Attention: Angela Cleary
Brisbane City Council Reference: A006836143
Proposal: Development Permit for a Material Change of Use of Premises to Establish a Multiple Dwelling

RE: RESPONSE TO MEMORANDUM FROM WRM REGARDING DEVELOPMENT PERMIT FOR A MATERIAL CHANGE OF USE OF PREMISES 140 & 142 FRASERS RD MITCHELTON (DATED 4 DECEMBER 2025)

Figure 1 – Existing Stormwater Basin (Southern Side of Development Site)

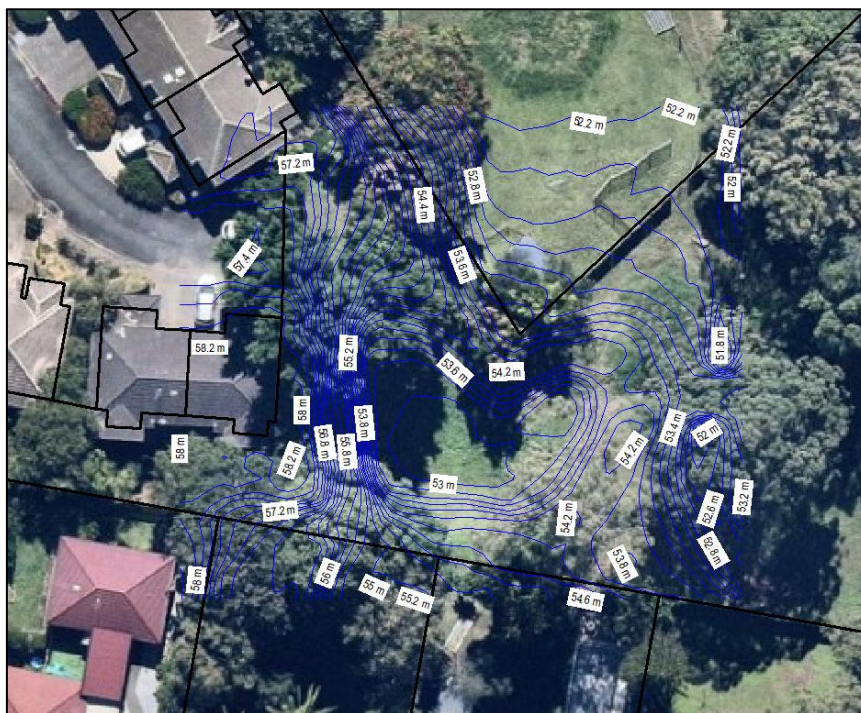
- *Adopted % impervious values selected for low density urban residential development only, ignoring existing adjacent higher density townhouse developments and producing a very low estimate of developed conditions % impervious for the Site;*

Response 5: The average density of the townhouse developments have been checked and contain a mix of high density and open space/vegetated areas. The average fraction impervious for these catchments has been checked via aerial imagery and is considered appropriate. Furthermore, these development sites are likely to have onsite stormwater detention (evidenced by the existing stormwater basin picture below). These developments are required to ensure no increase in peak flows discharging from their sites.
